## UPPER TRISHULI-1 HEP (216MW)

### REVIEW NOTE

<b>Title of the Document</b>	<b>Excavation and Initial Support Drawings of Adit No. 3</b>
------------------------------	--

<b>Review Note No.</b>	<b>RN-0054</b>	<b>Present Review Date</b>	<b>04.02.2022</b>
		<b>Present Review Status</b>	<b>AN</b>

Drawing UT1-C-150-CVL-DG-43004-01, Rev. 0

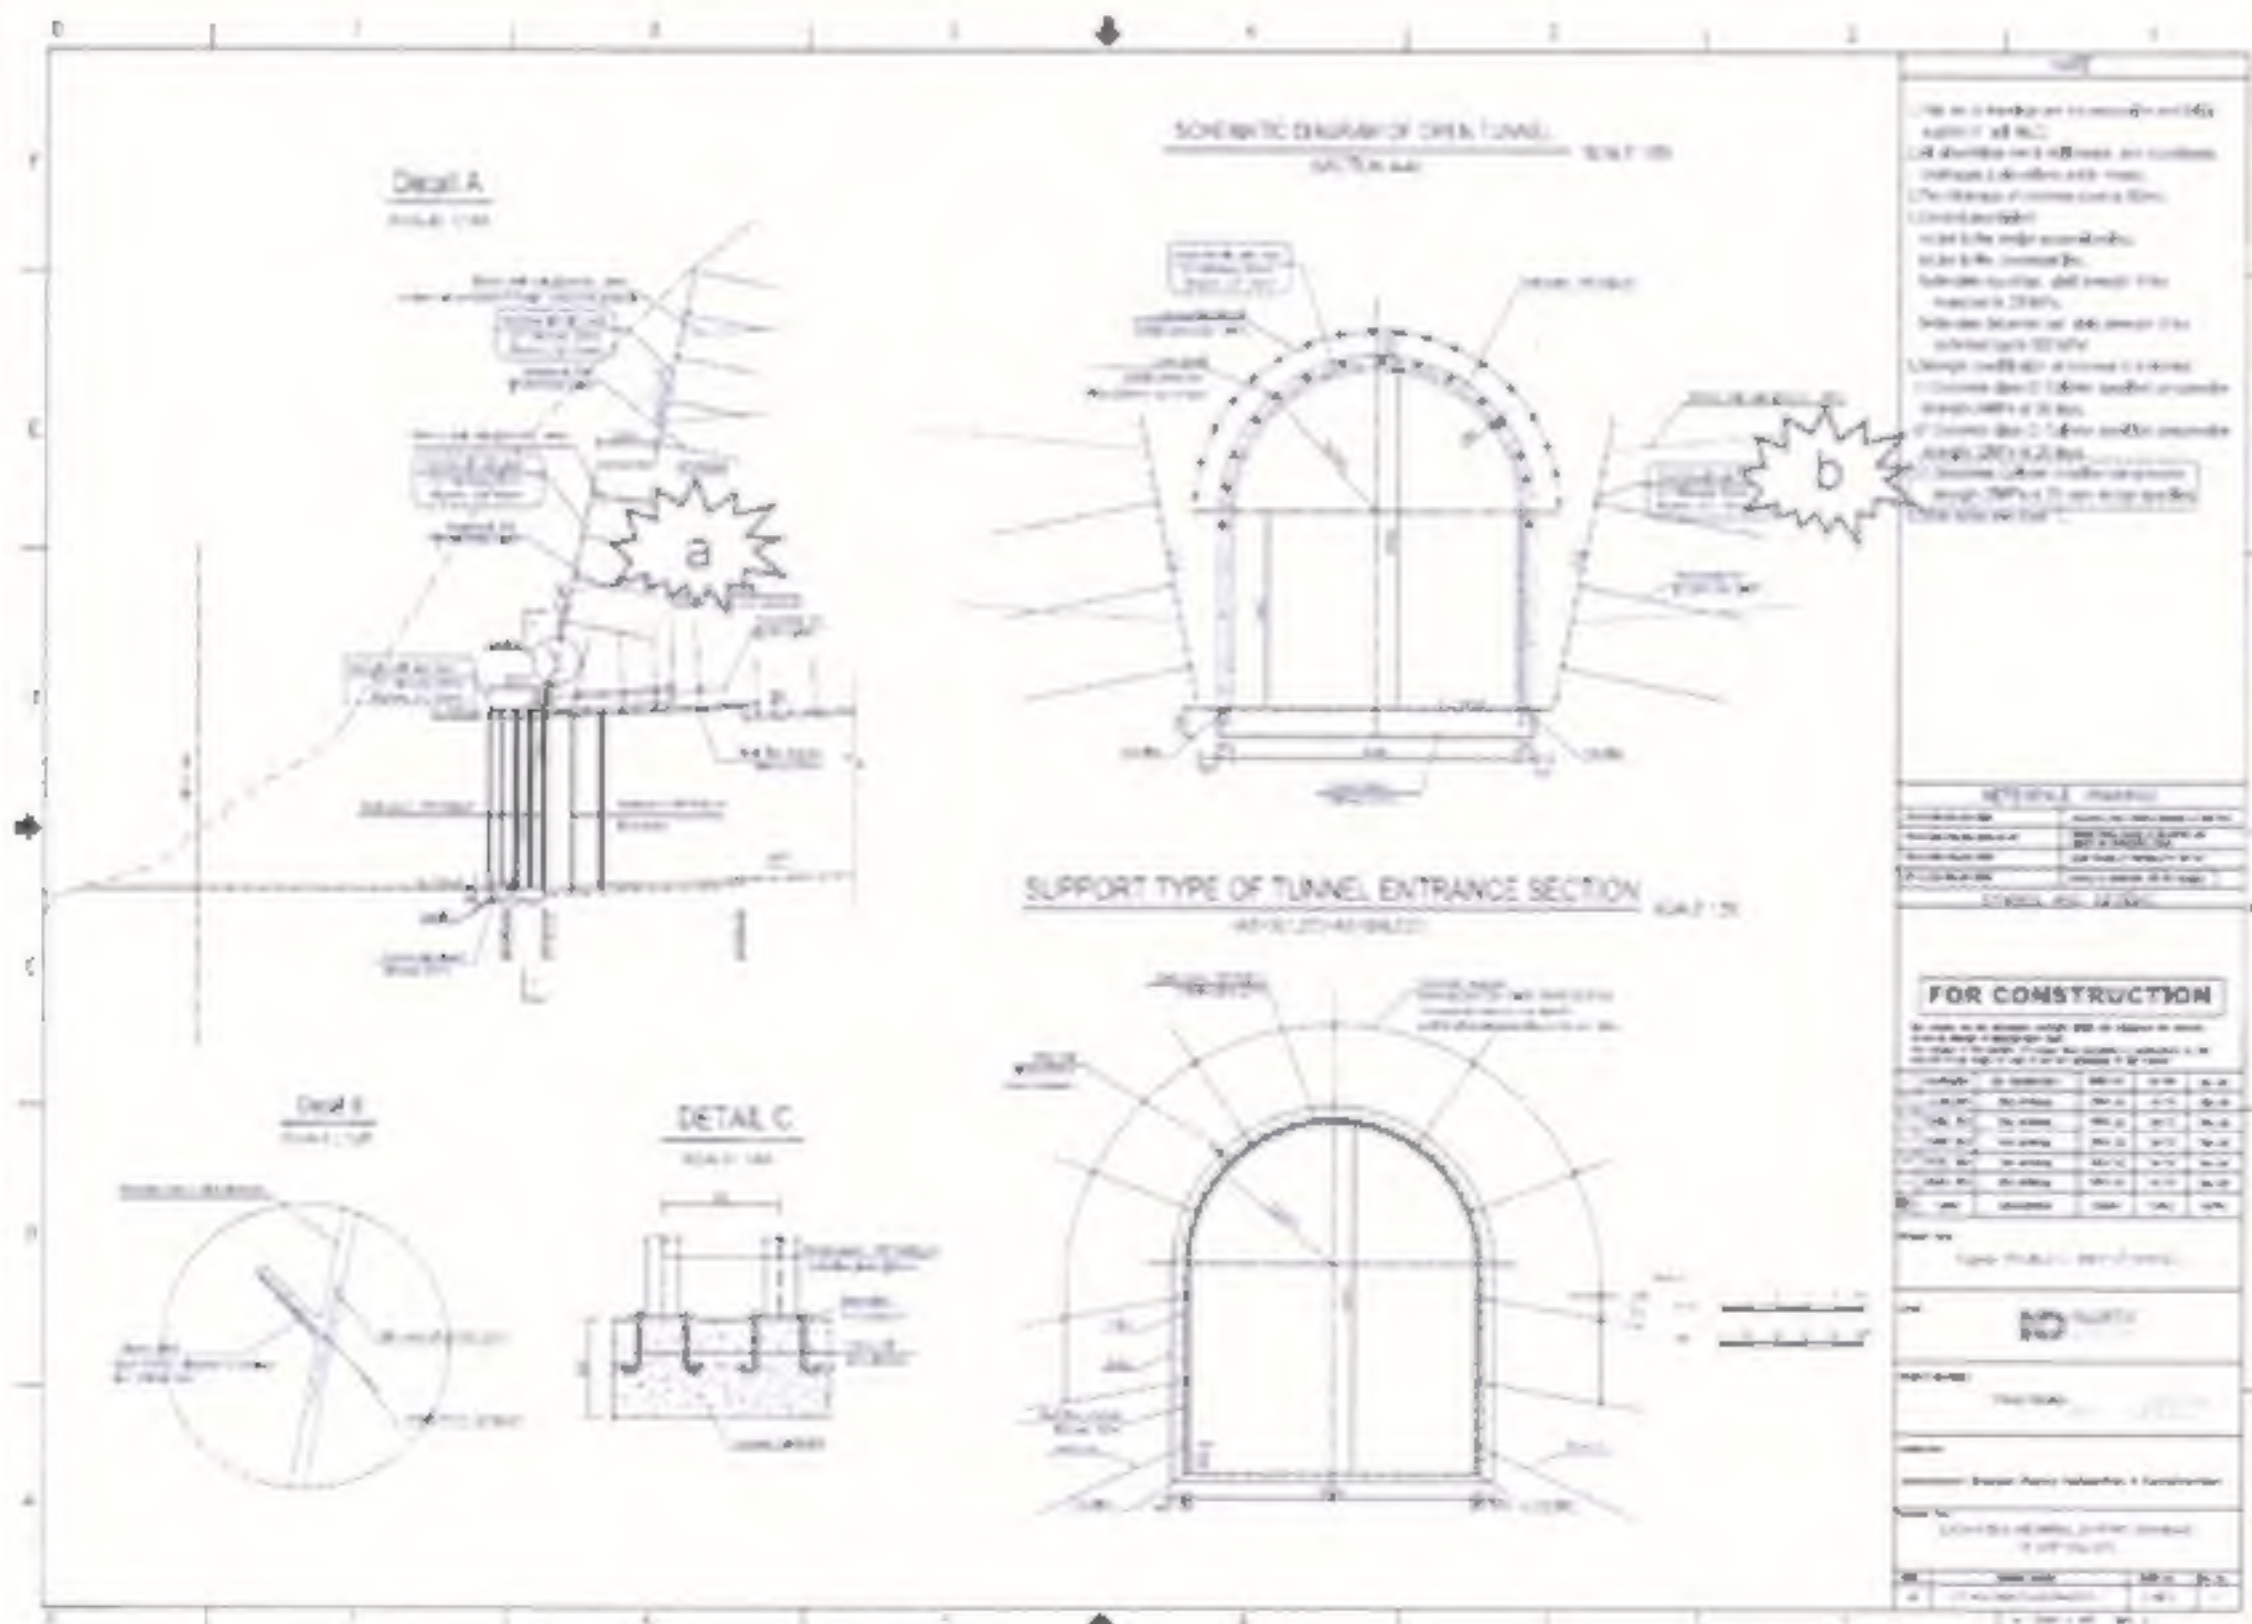
a) Add to the sentence "This drawing... ..in the execution stage, with written approval of the OE."

Drawing UT1-C-150-CVL-DG-43004-02, Rev. 0

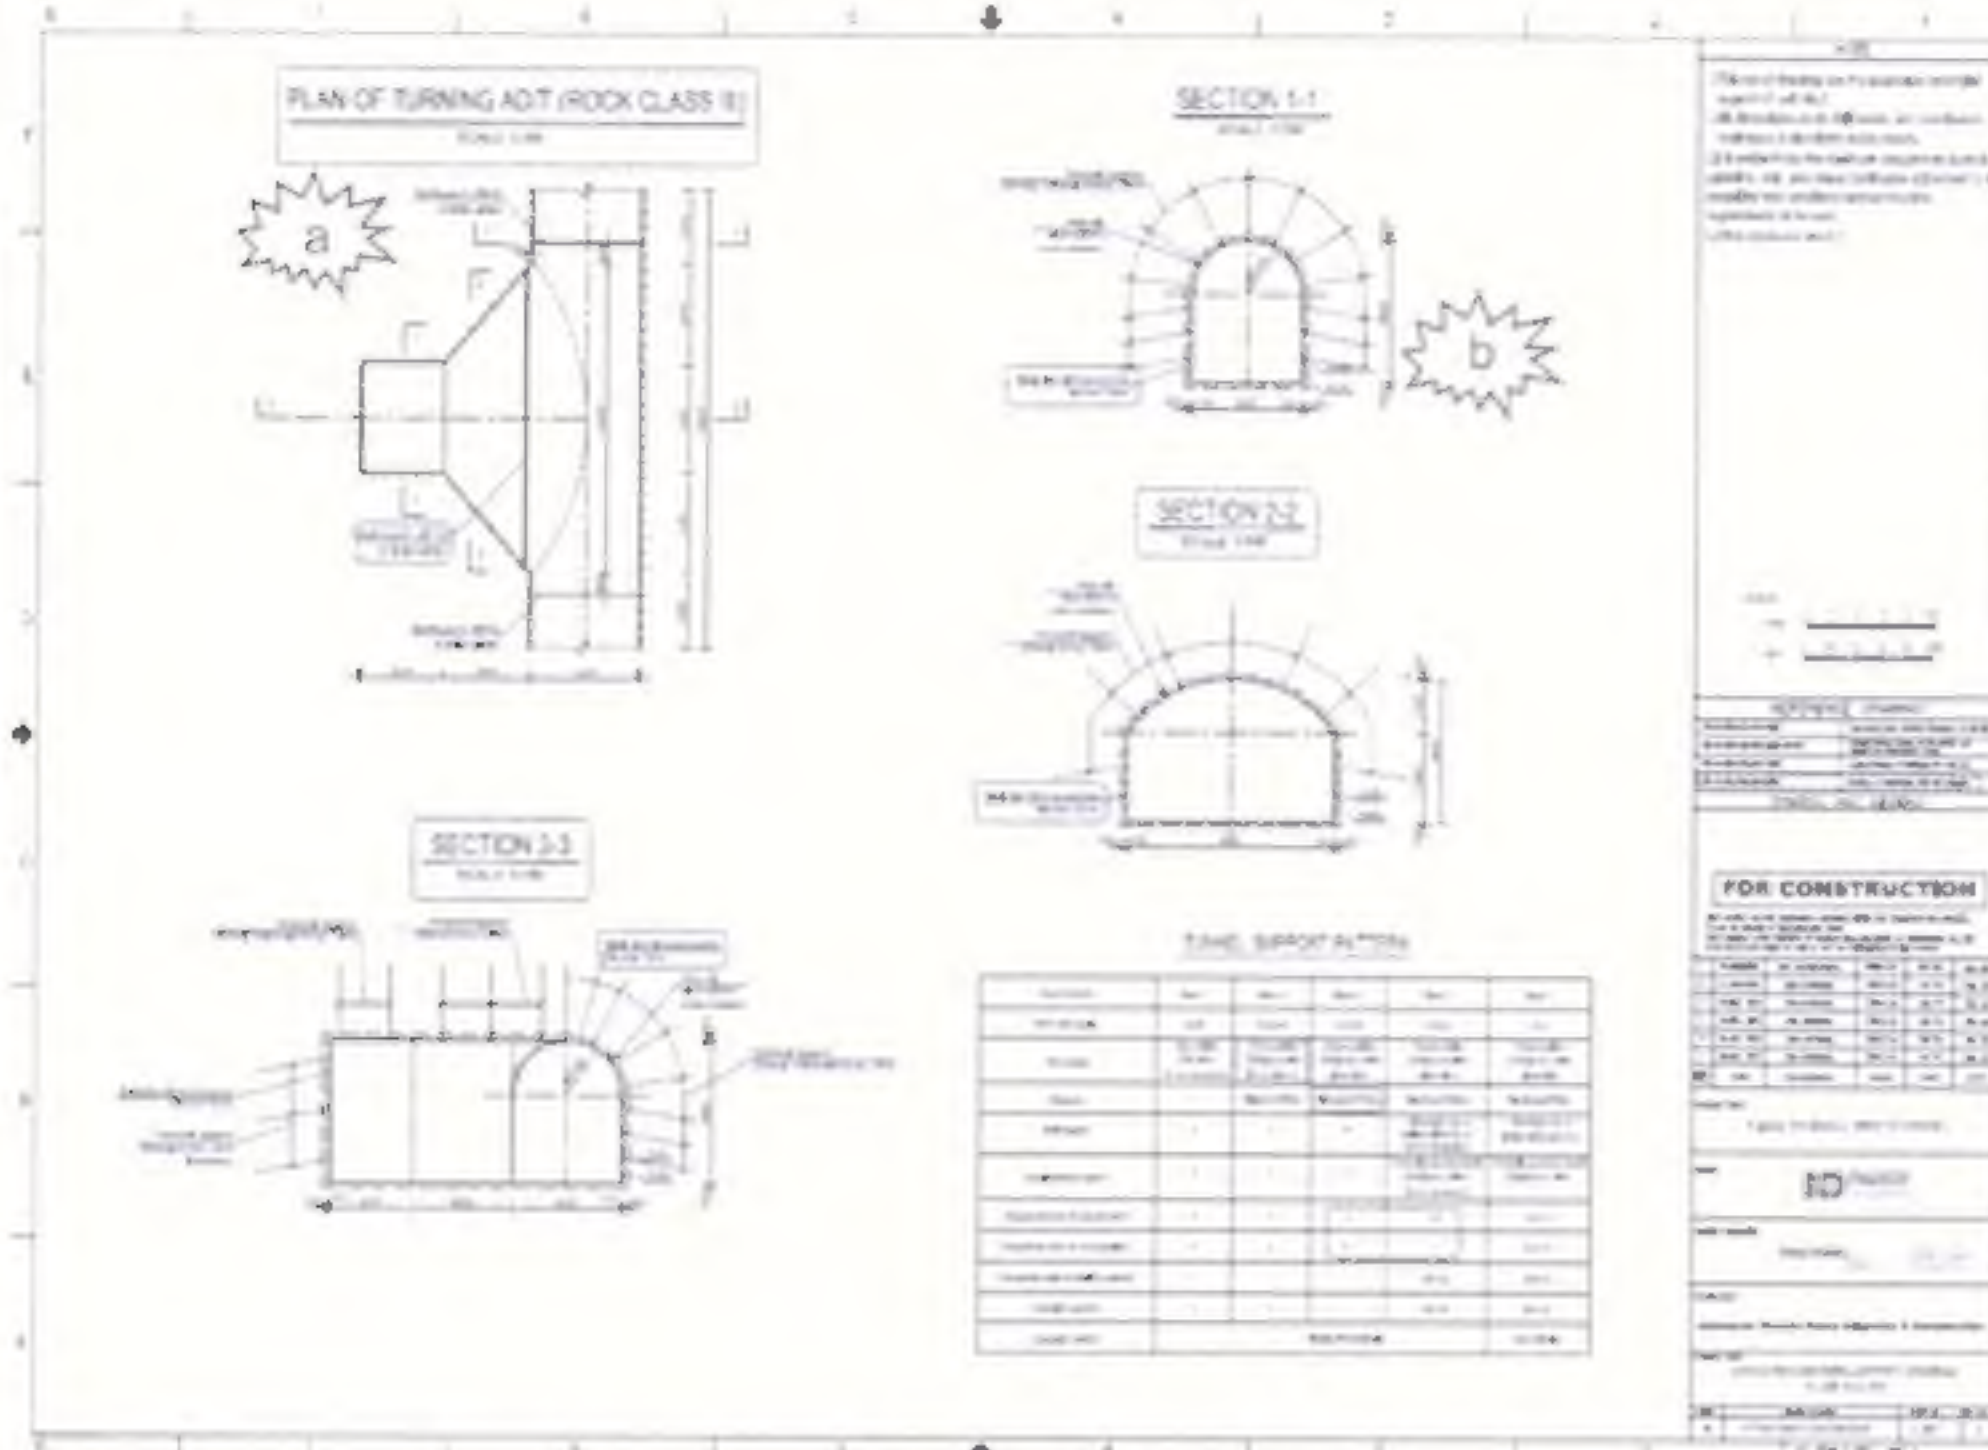
a) Replace the 3 m long drain holes with weep holes (for rock slopes).

b) Provide a note that refers to the early strength requirements as per contract.

Drawing UT1-C-150-CVL-DG-43004-03, Rev. 0

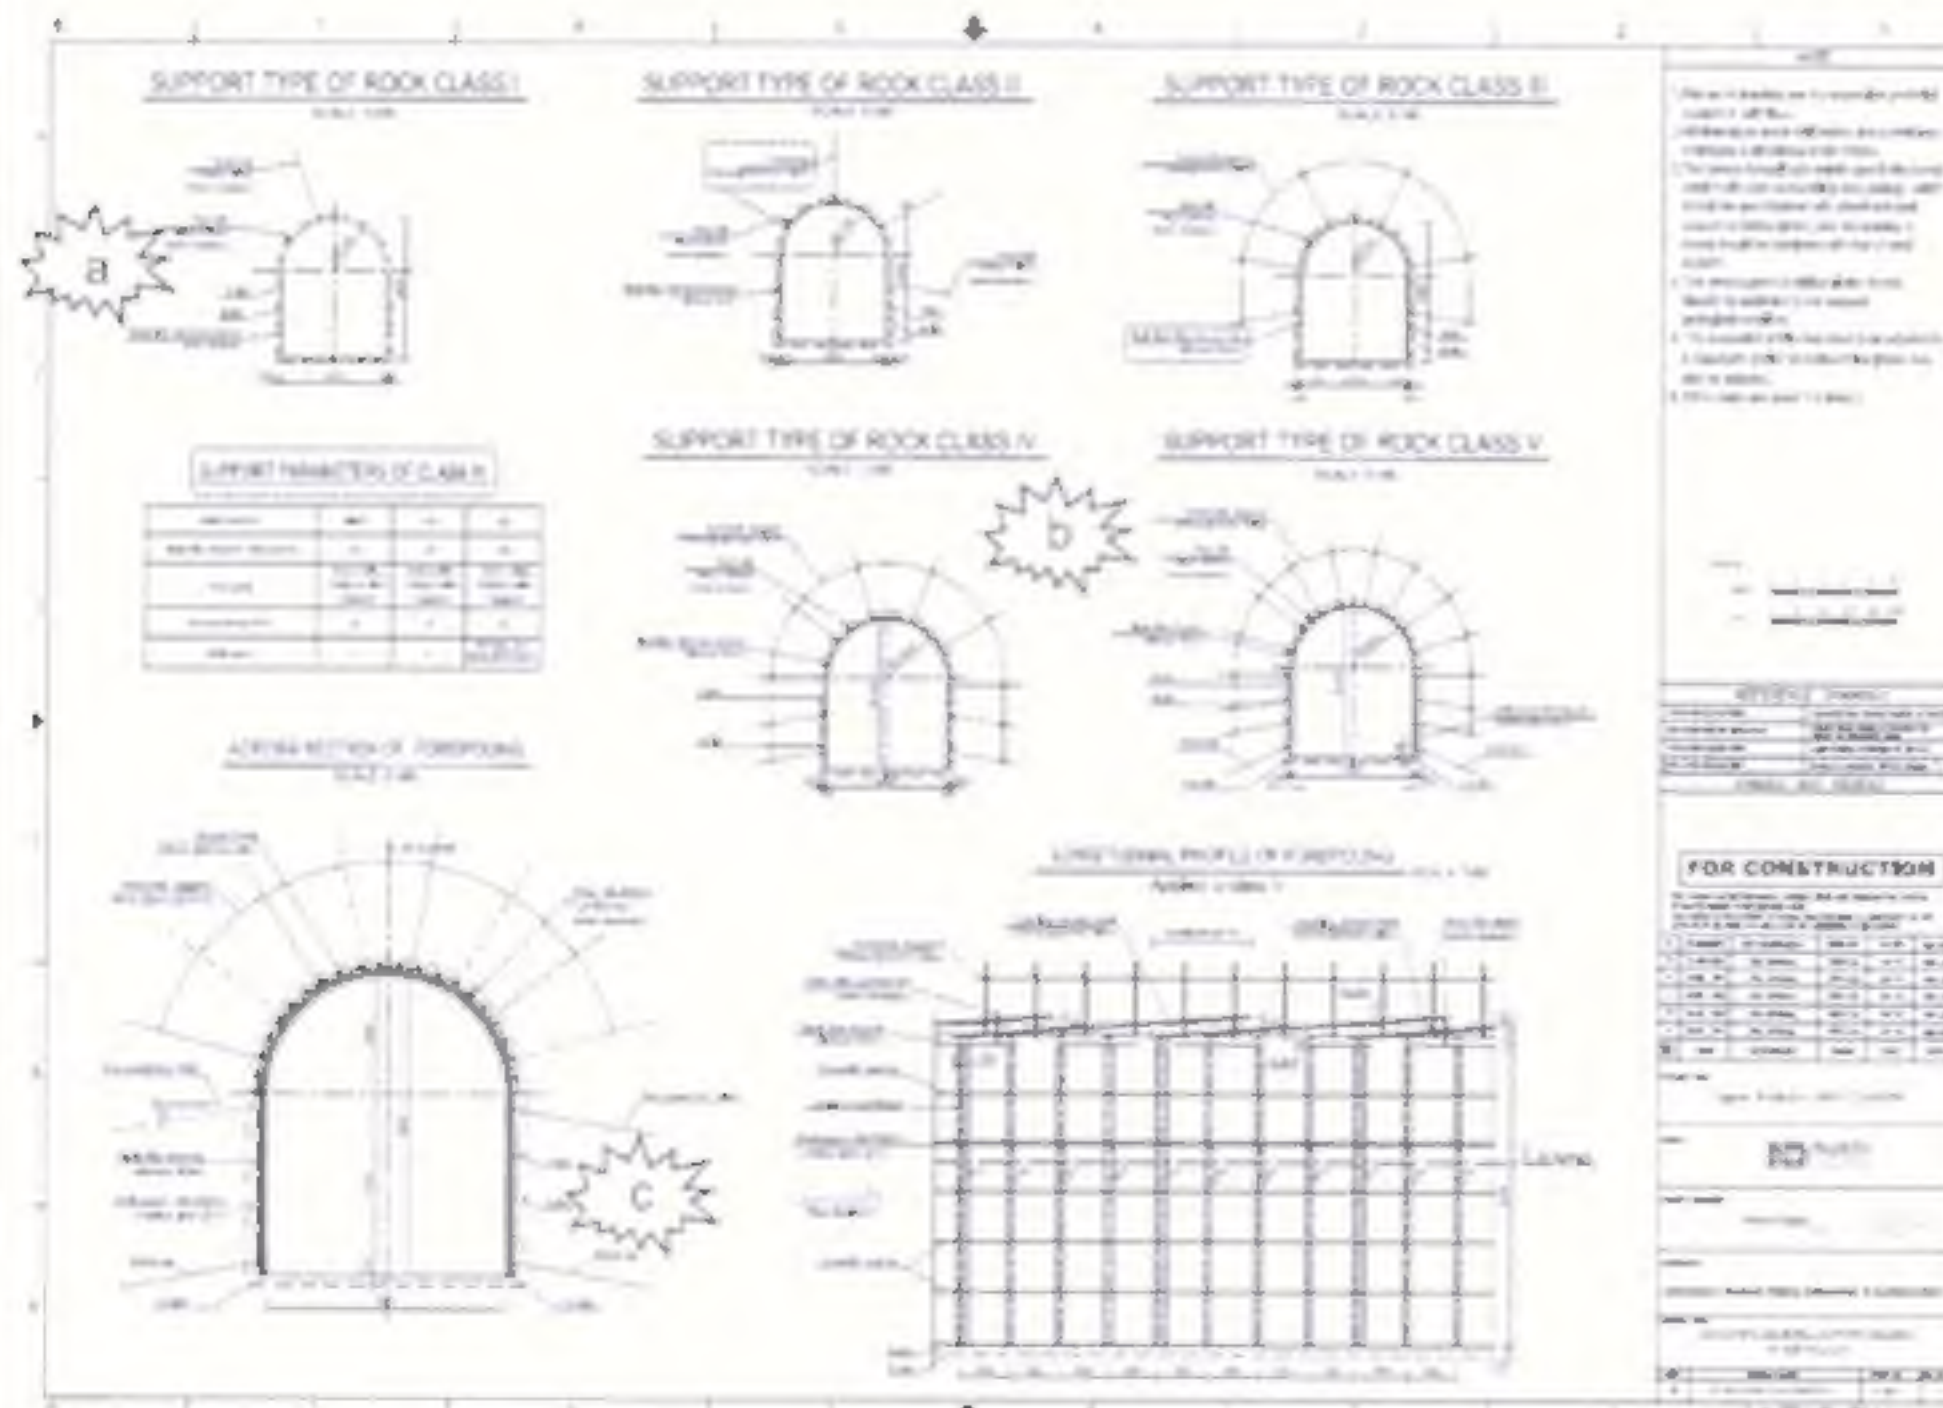
- a) Note that the steel ribs at the start and end of the turning bay are only required in Class III, IV and V.
- b) For Class III in sidewalls no rock dowels below 1.5 m required. Revise.
